# UNITED STATES PATENT AND TRADEMARK OFFICE

<b>Office Action Summary</b>	<b>Application No.</b>	<b>Applicant(s)</b>
	10/802,640	CONWAY, JAMES F.
	<b>Examiner</b>	<b>Art Unit</b>
	Tan Le	3632

## **DETAILED ACTION**

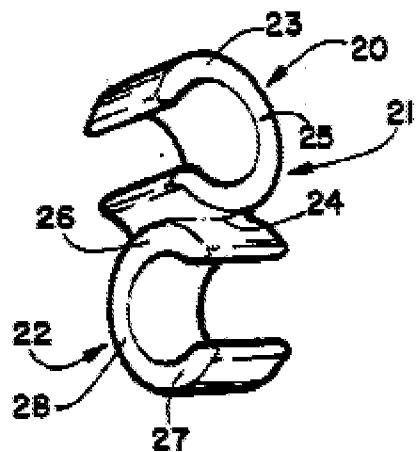
As to claims 16, 20, 21 and 5, Bechtel et al teaches a re-bar clamp assembly (Fig. 2) comprising all the limitations as claimed, which clearly shows on the attached Figure 2, comprising a pair of first arms 21 and a pair of second arms (22), each pair of arms defining an elongated open mouth channel wherein the open mouth channel receives at least a portion of the display (receives steel bar 13) (Fig. 1).

As to claims 2-3 and 17-19, Bechtel et al. device also shows a flared outwardly at the ends of each of pair of arms (see Fig. 2 for clarity).
